DEVELOPMENT PERMIT MCUI/86/2002

MATERIAL CHANGE OF USE - PLACE OF WORSHIP

363-367 KINGSTON ROAD, KINGSTON

MCUI/86/2002 APPROVAL OF LANDSCAPE PLAN WITH COUNCIL ENDORSEMENTS

title
landscape plan

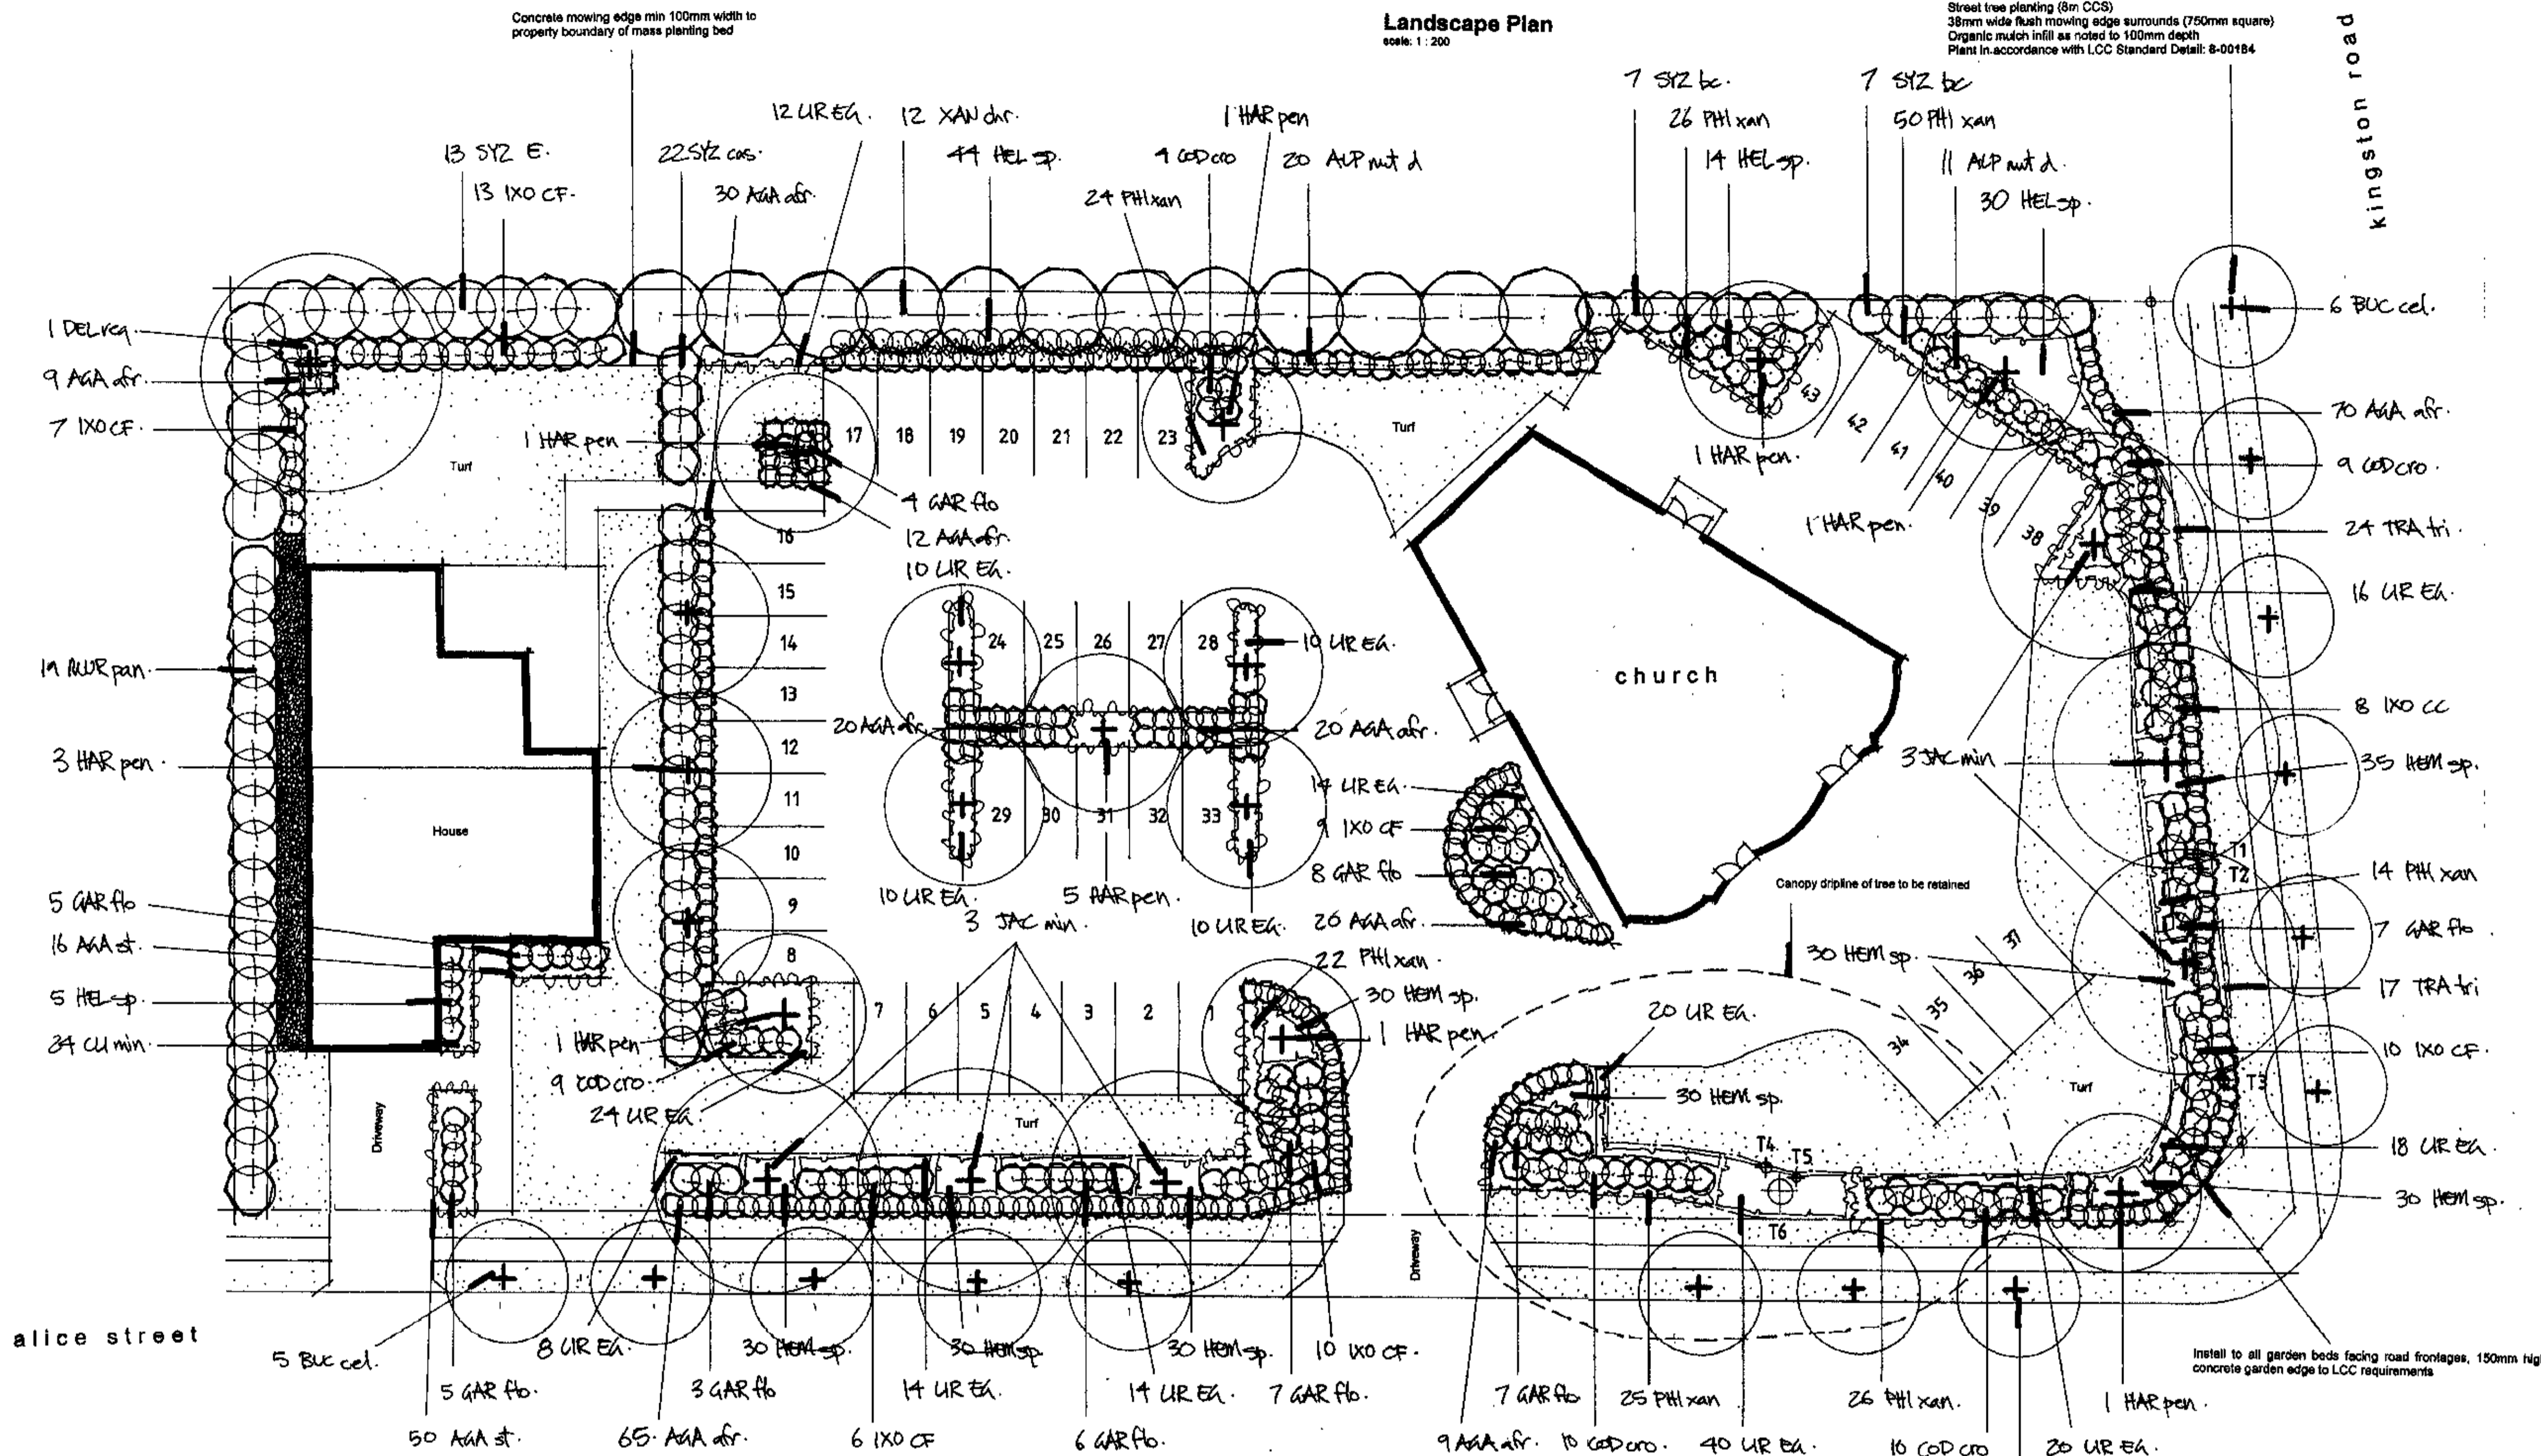
Council has assessed the 'Landscape Plan', sheet '1 of 1' issue 'A', prepared by Donald Irving Landscape Architecture Vegetation Analysis, in association with Andrew Gold Landscape Architect, for the abovementioned development. Please be advised that the plan is acceptable for approval, subject to the following Council endorsements:

1. Street tree specimens which have been tip-pruned will be rejected.
2. Tree guards to street trees in accordance with condition 8.4.3 of the development permit. Contact Council" Parks Depot on 3826 5338 to discuss street tree cage specifications.
3. Organic mulch surfaces are to finish 25-38mm below the adjacent surface levels.
4. Ground covers to areas endorsed on the plan.
